IDEA PUBLIC SCHOOLS – Lower Valley Building Envelope

GMS ARCHITECTS
BROWNSVILLE, TEXAS 78526
(956) 546-0110

ADDENDUM NO. 3

01 SITE PLAN
 SCALE: 1:40

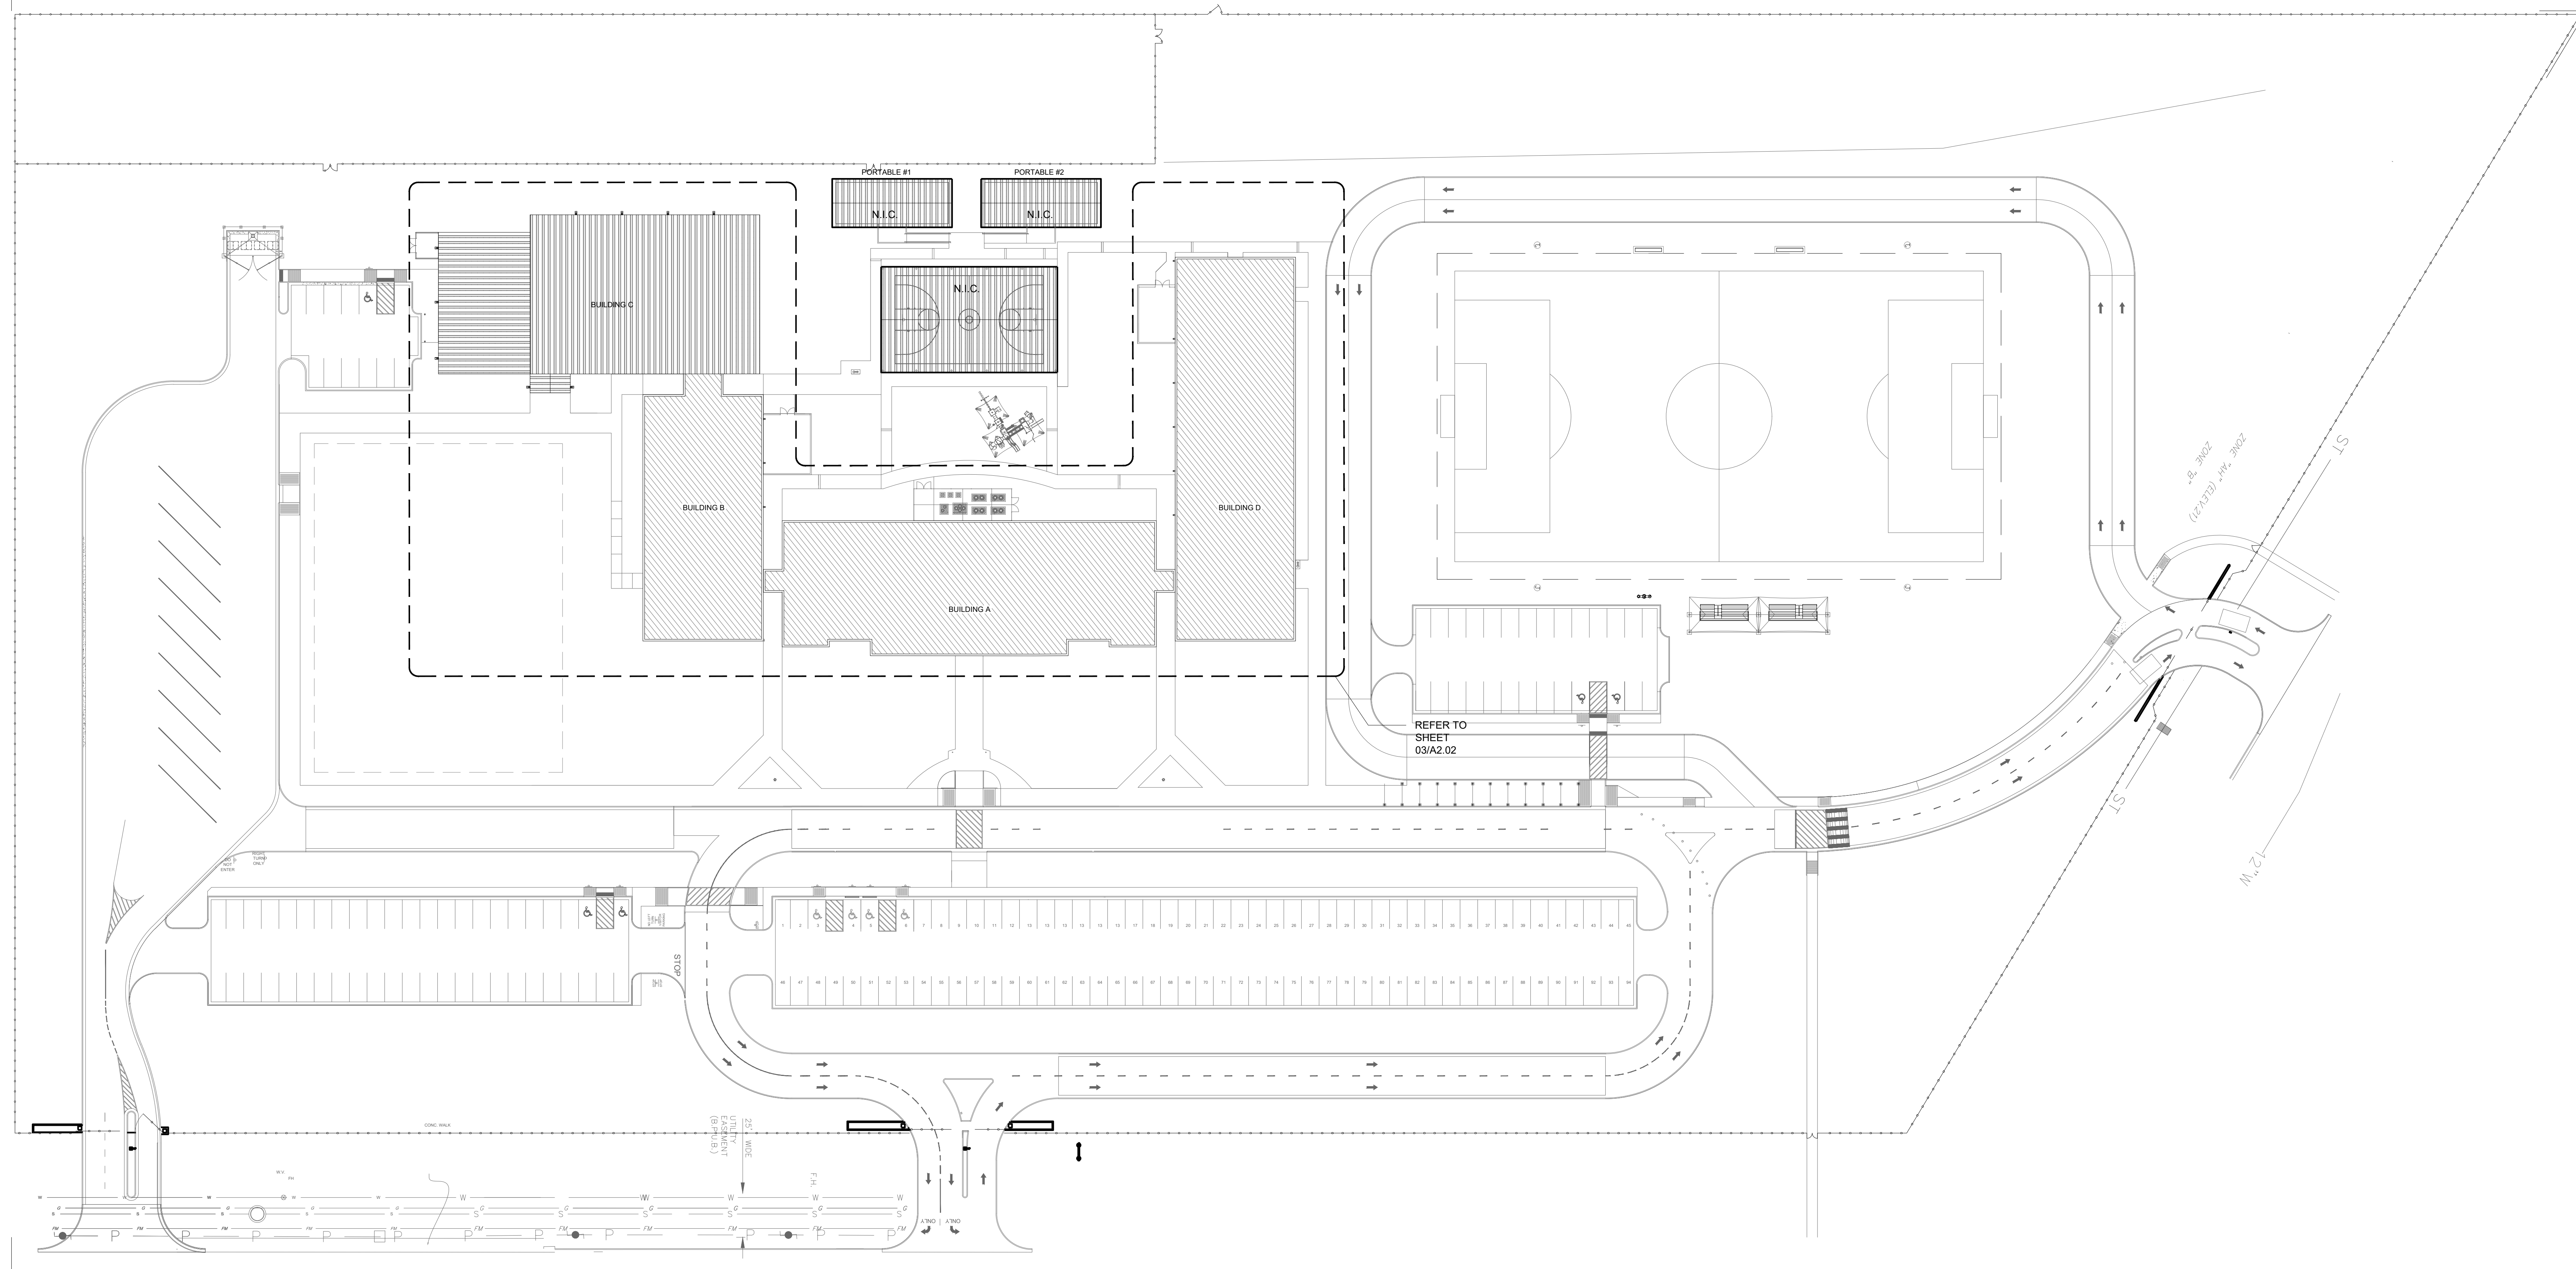
1. PROVIDE UNIT PRICING IN BID AND LINE ITEM FOR REPLACING METAL PANELS FOR PUNCTURED BY BULLET HOLES.
2. PROVIDE UNIT PRICING AND LINE ITEM TO REPLACE SIDEWALK CANOPY PURLINS

1. PROVIDE ALTERNATE #1 FOR WORK TO BE PERFORMED DURING AFTER SCHOOLS HOURS AND WEEKENDS.

01 SITE PLAN
 SCALE: 1 = 20

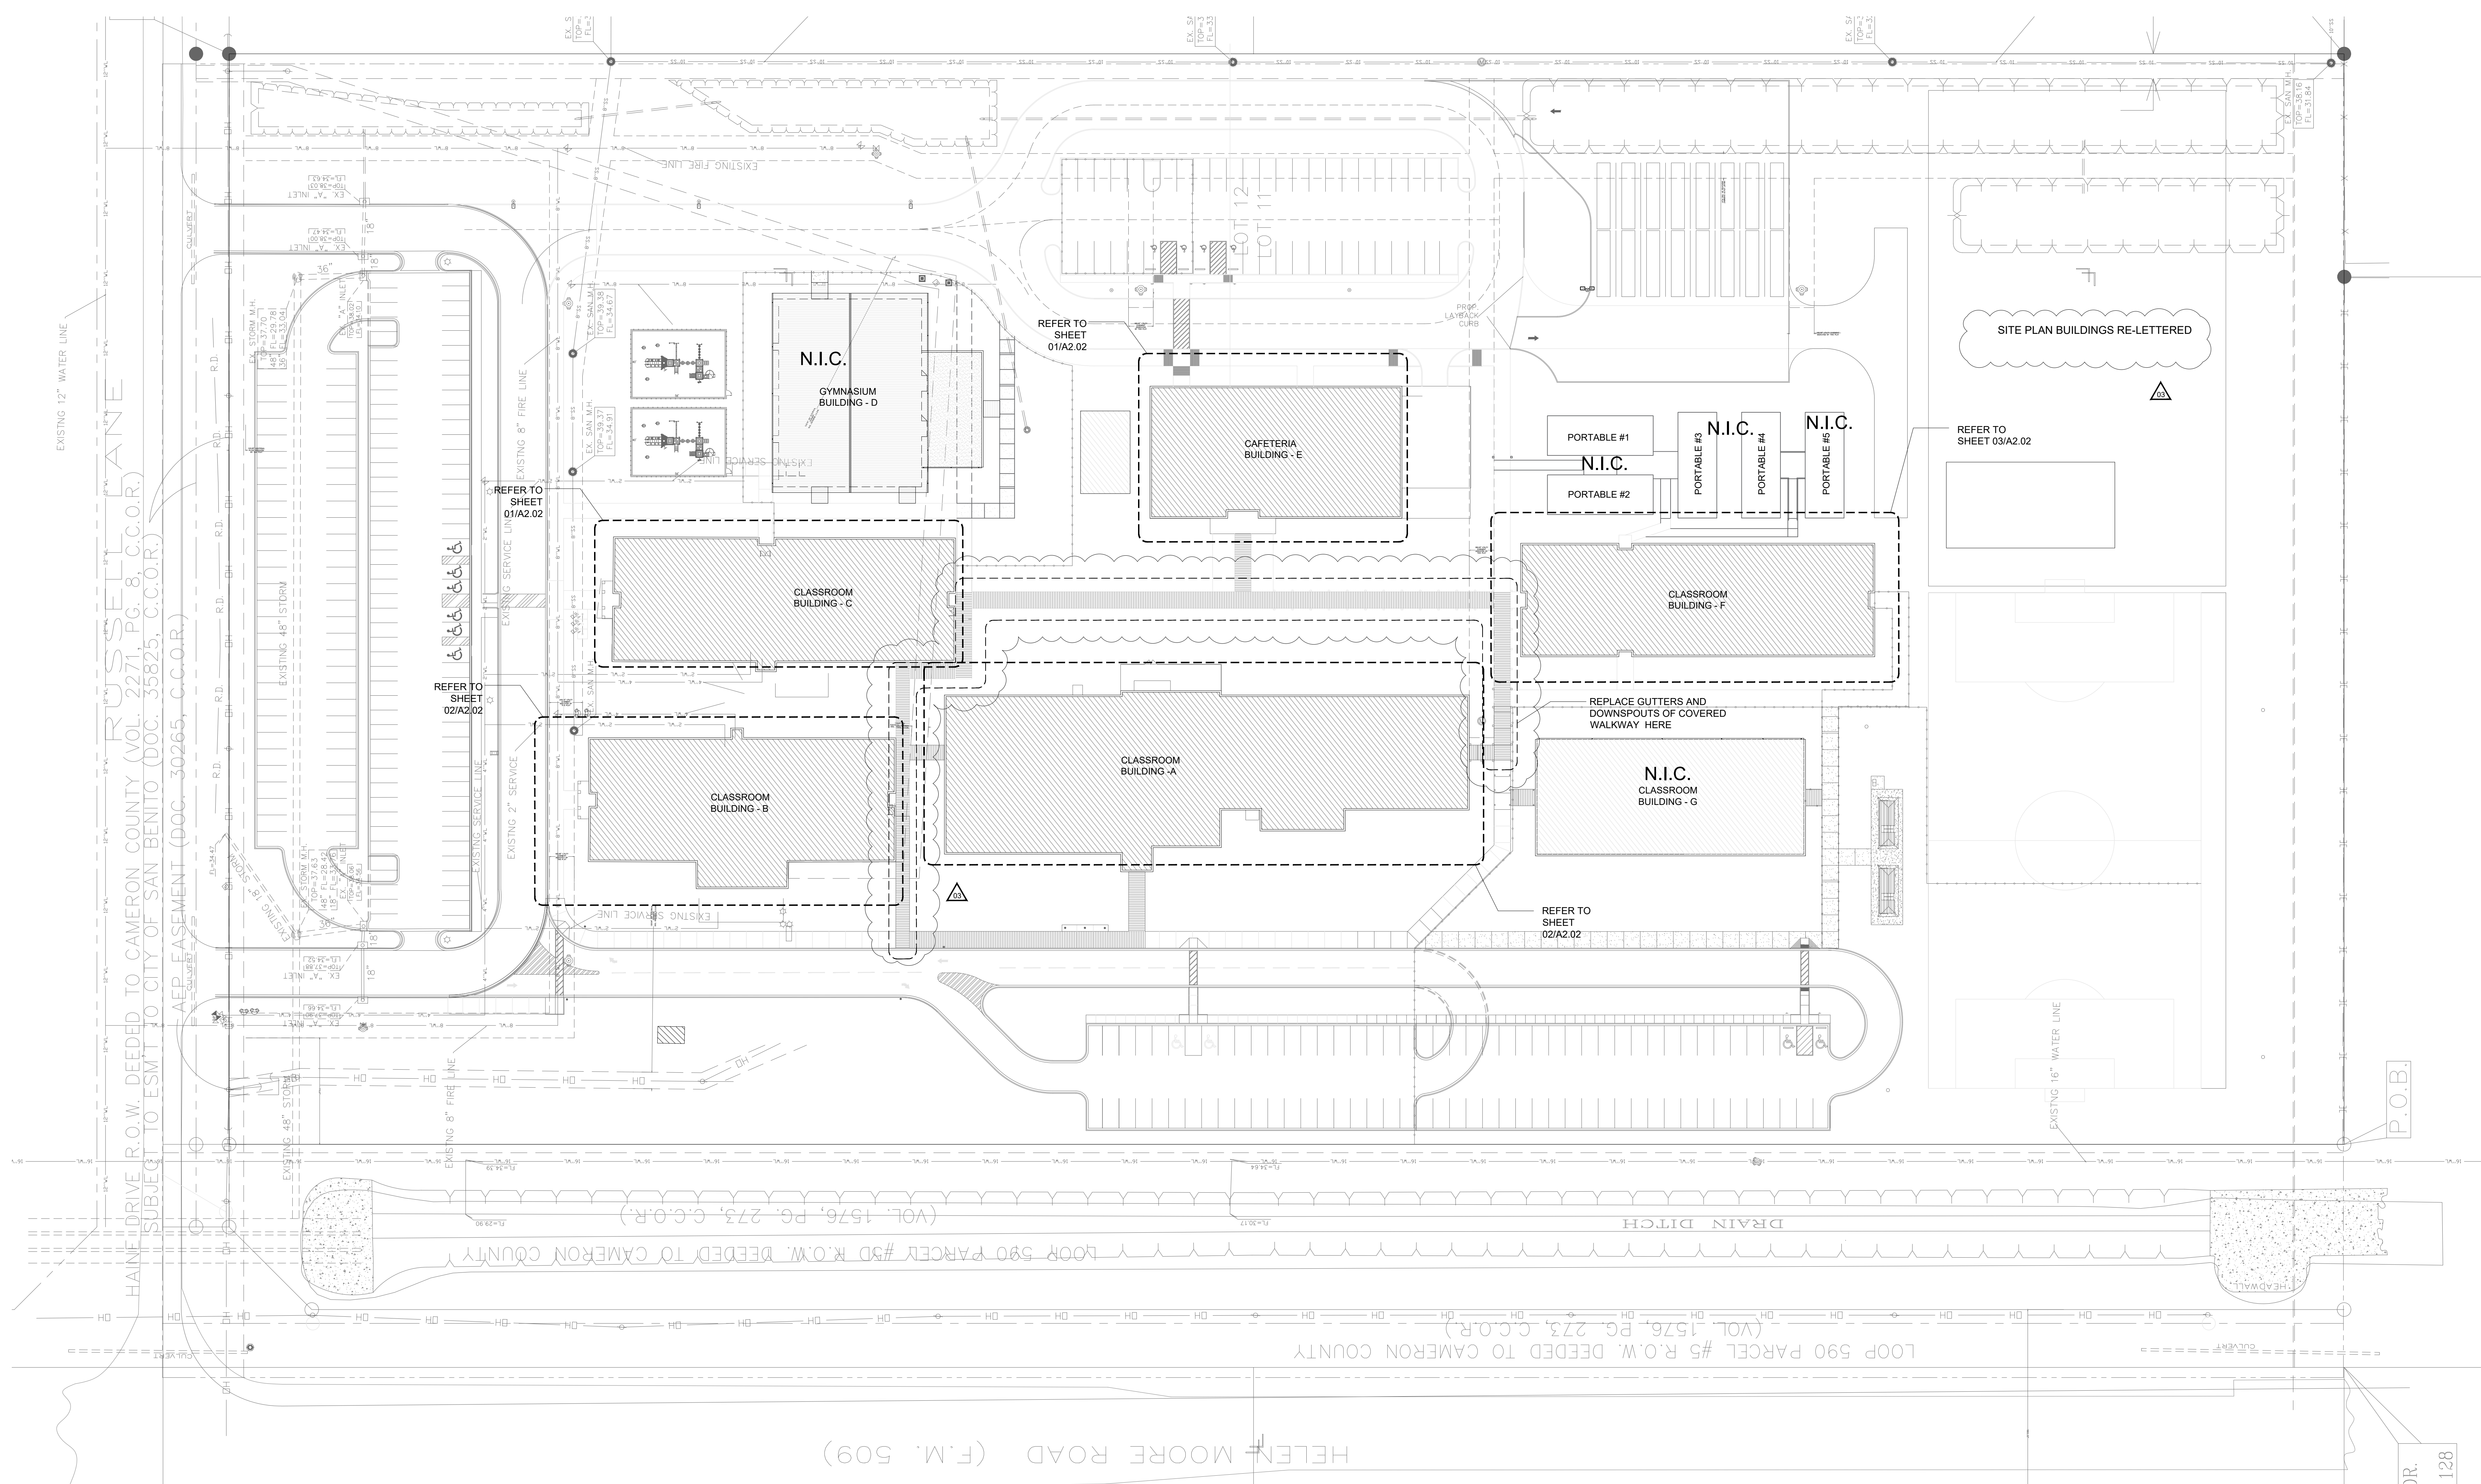
1. PROVIDE UNIT PRICING AND LINE ITEM TO REPLACE GUTTERS AND DOWNSPOUTS FOR CANOPIES AT COVERED WALKWAY

1. PROVIDE ALTERNATE #1 FOR WORK TO BE PERFORMED DURING AFTER SCHOOLS HOURS AND WEEKENDS.
